ATTACHMENT 1

- A. Evaluation of the potential impact of using fuel rod models presented in draft NUREG-0630 on the Loss of Coolant Accident (LOCA) analysis for Turkey Point units 3 & 4 with 25% SGTP and 5% red.TDF.

Figure 3.2-3b

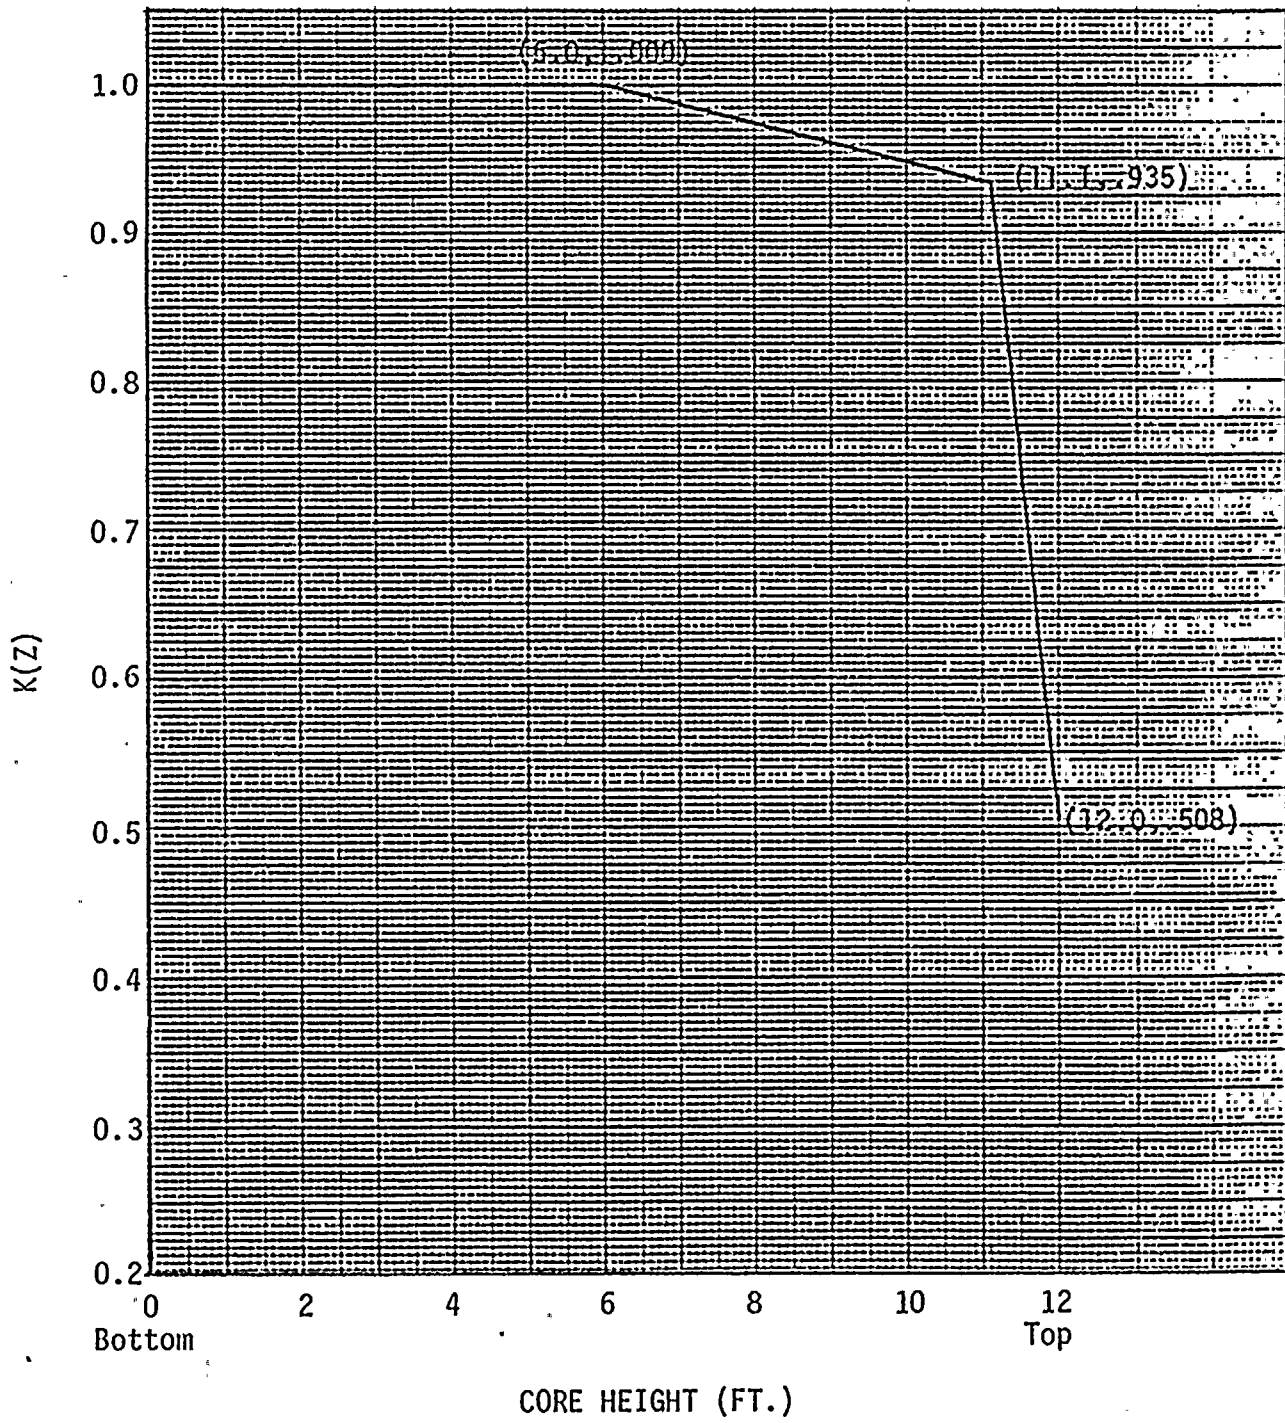
- (1) With steam generator tube plugging >22% and ≤25%, the hot channel factors (defined in the basis) must meet the following limits at all times except during low power physics tests:

$$F_q(Z) \leq (1.97/P) \times K(Z), \text{ for } P > .5$$

$$F_q(Z) \leq (3.94) \times K(Z), \text{ for } P \leq .5$$

$$F_{\Delta H}^N \leq 1.55 [1.0 + 0.2(1-P)]$$

Where P is the fraction of rated power at which the core is operating; K(Z) is the function given in Figure 3.2-3b; Z is the core height location of F_q .

If F_q , as predicted by approved physics calculations, exceeds 1.97, the power will be limited to the rated power multiplied by the ratio of 1.97 divided by the predicted F_q , or augmented surveillance of hot channel factors shall be implemented.
